PROPOSED IMPROVEMENT  
BRIDGE PROJECT  
TOWN OF GRANVILLE  
COUNTY OF ADDISON  
PROJECT STP 013 - 4(38)

ROUTE NO.: VT 100  
BRIDGE NO.: 155  
PROJECT LOCATION: BR 155 OVER ALDER MEADOW BROOK  
APPROXIMATELY 5.7 MILES NORTH OF  
JUNCTION WITH VT 125

PROJECT DESCRIPTION: THIS PROJECT INVOLVES REMOVING AND REPLACING THE SHEET  
MEMBRANE WATERPROOFING AND BITUMINOUS CONCRETE  
PAVEMENT ON THE BRIDGE AND ITS APPROACHES ALONG WITH  
MINOR RELATED WORK.

**RECORD PLANS**

PROJECT NAME:	GRANVILLE		
PROJECT NUMBER:	STP 013 - 4(38)		
FILE NAME:	88b192-notes.dgn	PLOT DATE:	4/11/2013
PROJECT LEADER:	JPB	DRAWN BY:	MWS
DESIGNED BY:	PJM	CHECKED BY:	SRB
<b>INDEX OF SHEETS AND PROJECT NOTES</b> SHEET 2 OF 11

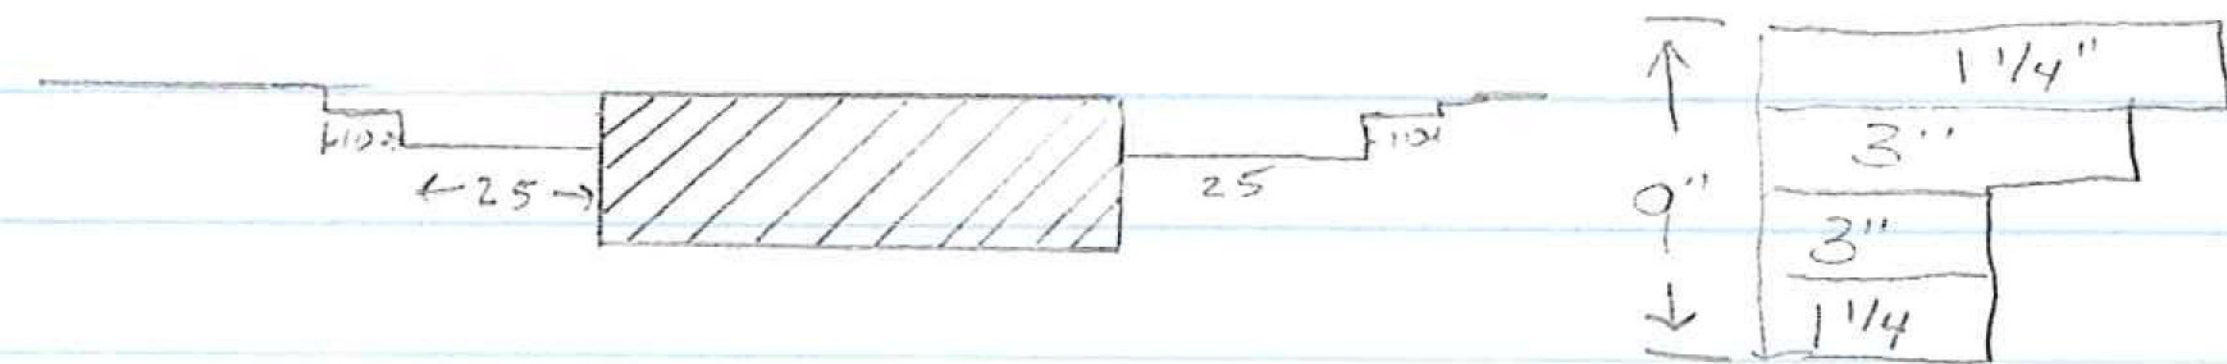
18. FOLLOWING THE INSTALLATION OF THE NEW SHEET MEMBRANE WATERPROOFING ON THE CONCRETE BRIDGE DECK, THE CONCRETE BRIDGE DECK SHALL BE PAVED CURB TO CURB WITH ITEM 900.680, "SPECIAL PROVISION (BITUMINOUS CONCRETE PAVEMENT, SMALL QUANTITY)" IN ~~TWO 1/4"~~ **FOUR** LIFTS. THE PAVEMENT SHALL BE TYPE IVS FOR BOTH LIFTS, NO EXCEPTIONS.

# QUANTITY SHEET 1

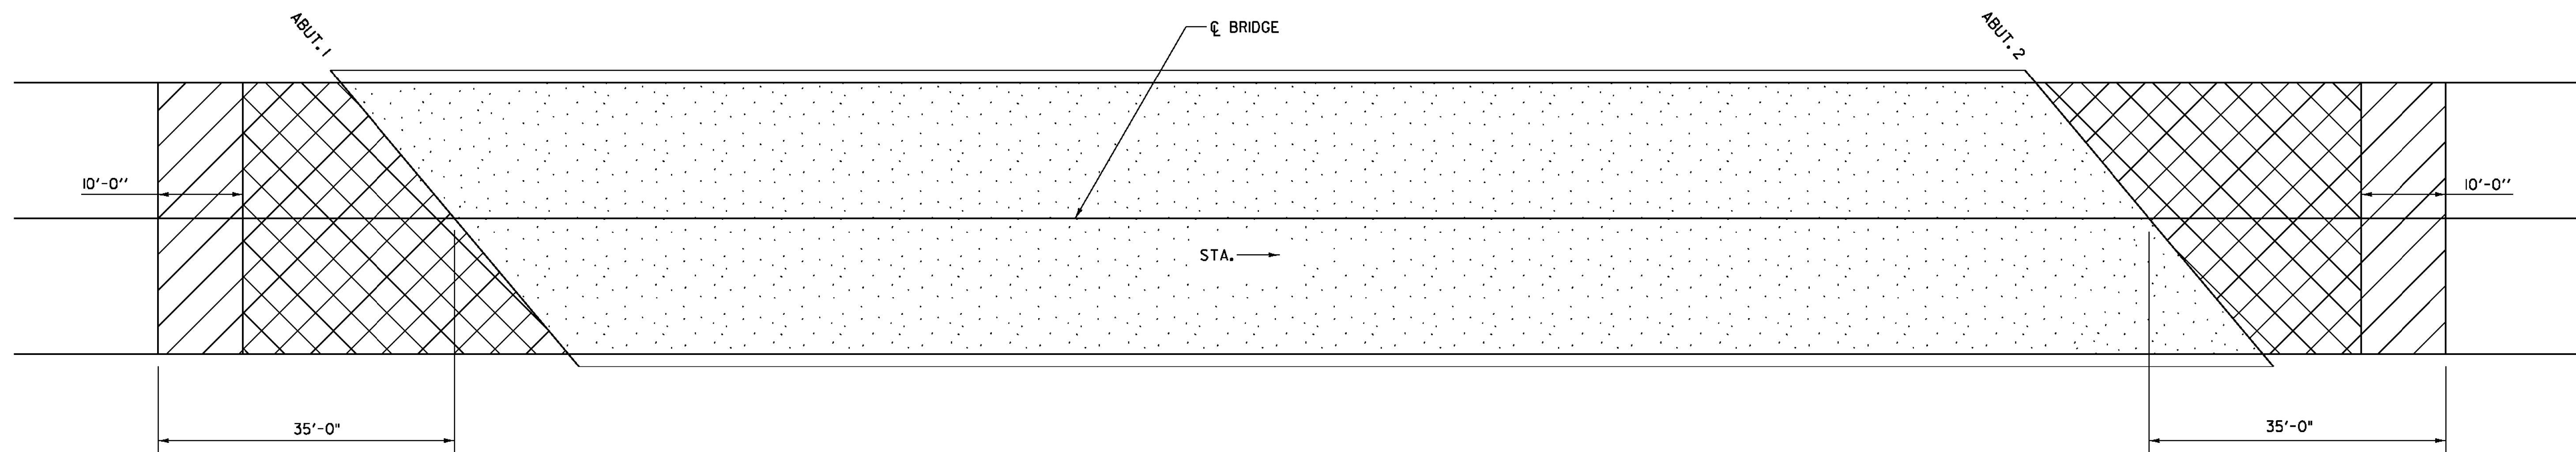
This is the way we did it.

North Approach  $35 \times 30.5 / 9 = 118.6 \text{ cy} \times \$20 \text{ per cy} = \$2372.22$

South Approach  $35 \times 30.5 / 9 = 118.6 \text{ cy} \times \$20 \text{ per cy} = \$2372.22$

North Approach  $25 \text{ FT} \times 30.5 \text{ FT} \times 4 \frac{1}{4} \text{\"/>}$

$10 \times 30.5 \text{ FT} \times 1 \frac{1}{4} \text{\"/>}$

South Approach Same as North

Bridge Deck  $32 \text{ FT} \times 30.5 \text{ FT} \times 0.75 \text{ FT} / 27 = 27.11 \text{ cy} \times 2 \text{ TON/cy} = 54.22 \text{ TON}$

Total TONS =  $70.04 \text{ TON} \times \$273.00 \text{ per TON} = 19,120.92$

This is the way we have proposed to them on how to complete the project. And with Change order we discussed

Cold planning would stay per plan. The only change would be addition of paving lifts and we had to add more traffic barrier because of the increase in longitudinal joint. Both of which we have items for

Total Cost =  $\$23,865.36$

**BITUMINOUS CONCRETE REMOVAL & REPLACEMENT PLAN**

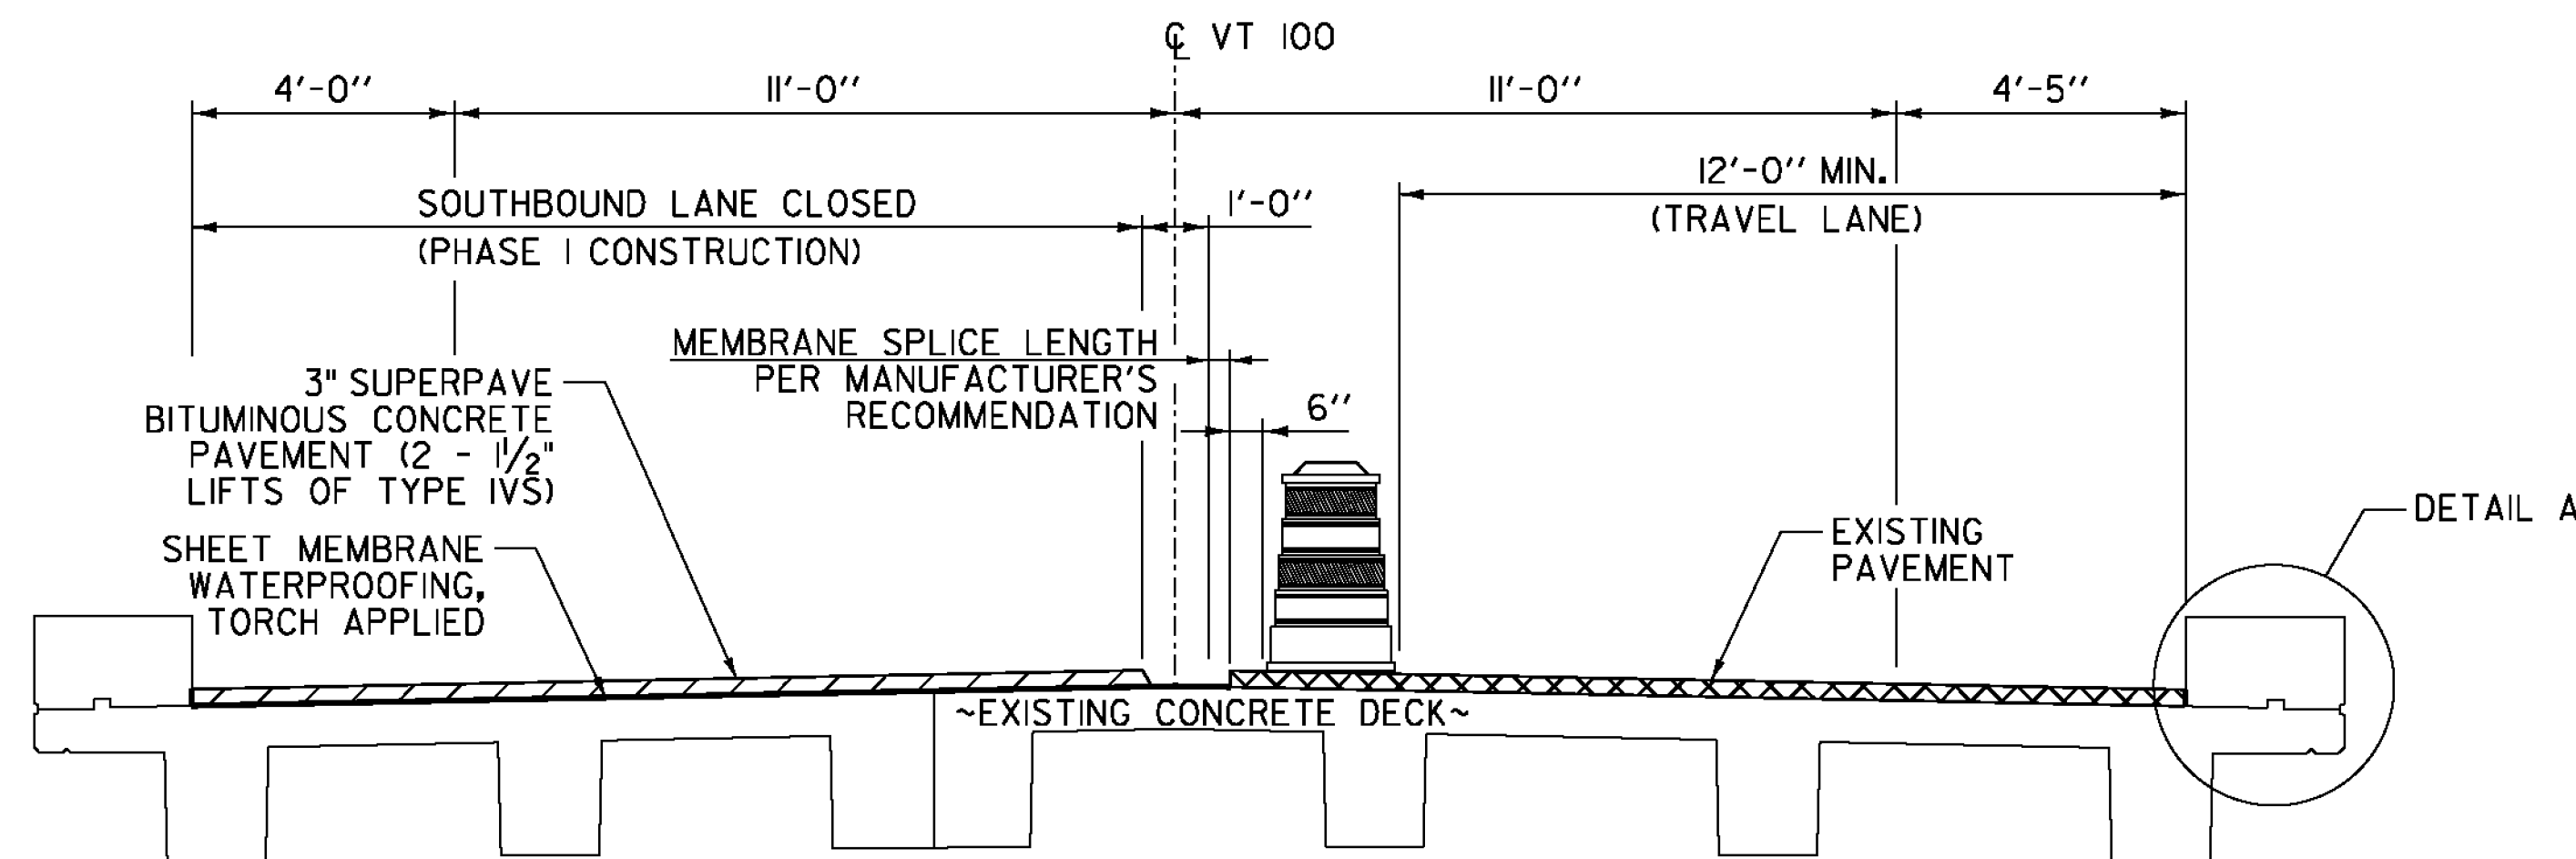
SEE PAGE 4A
